**In the Drawings:**

In compliance with the Examiner's requirements, Applicant submits herewith a set of formal drawings which incorporate all proposed amendments in the last response filed at the patent office.

FIG. 4

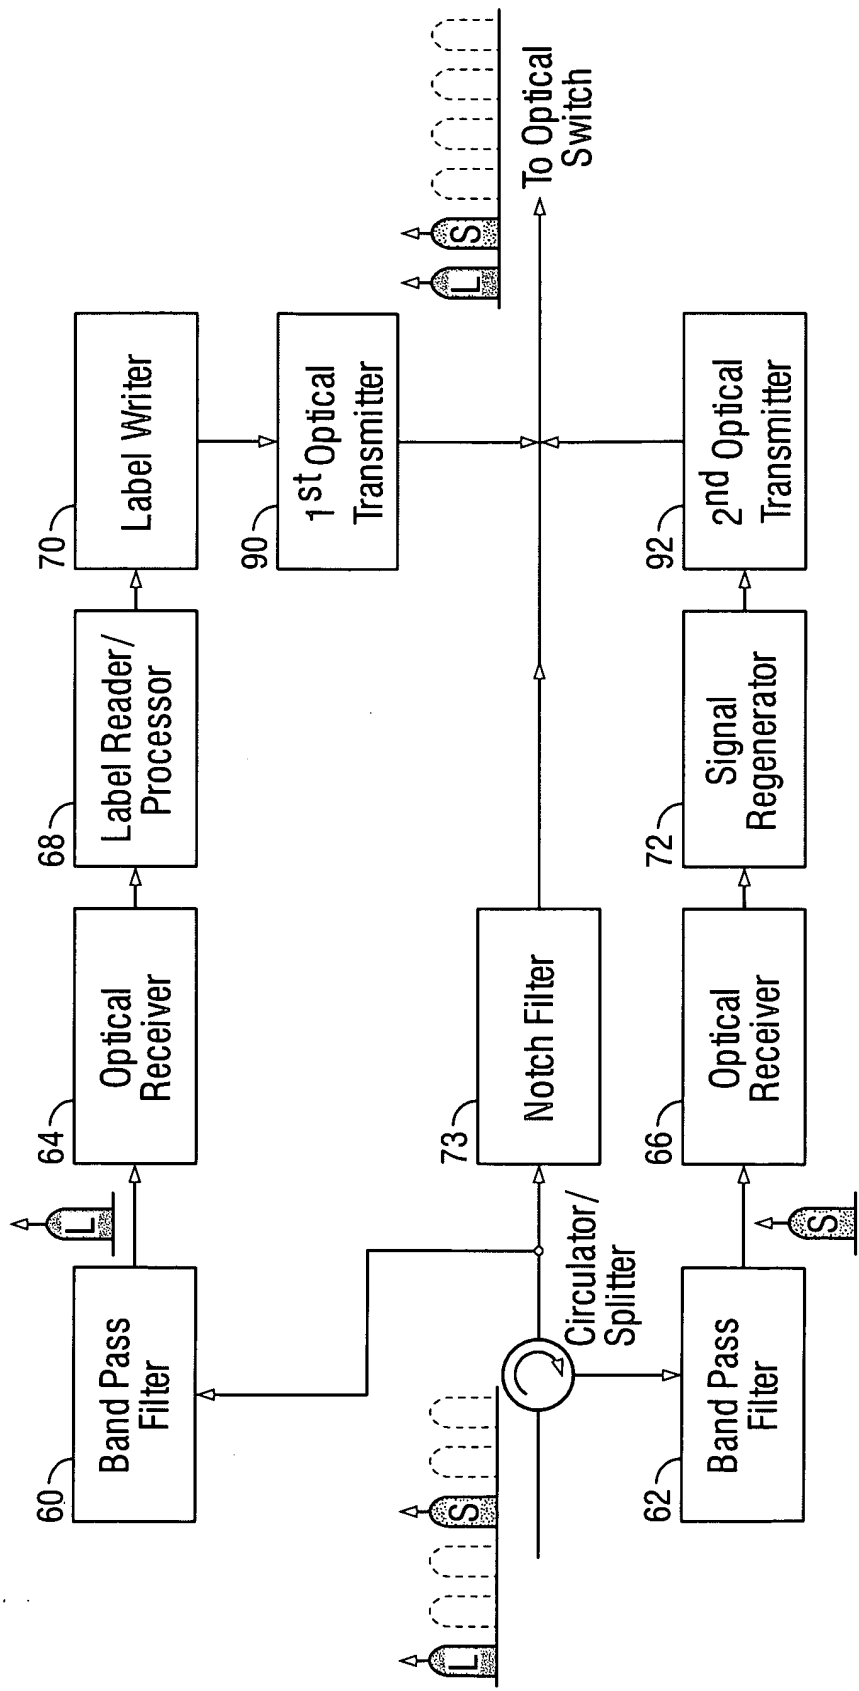
In addition, FIG. 4 has been further amended to remove an extra arrowed line in the spectrum of the output signal. This change simply conforms FIG. 4 to the textual description on page 13, lines 11-16 of the original specification. No new matter is added.
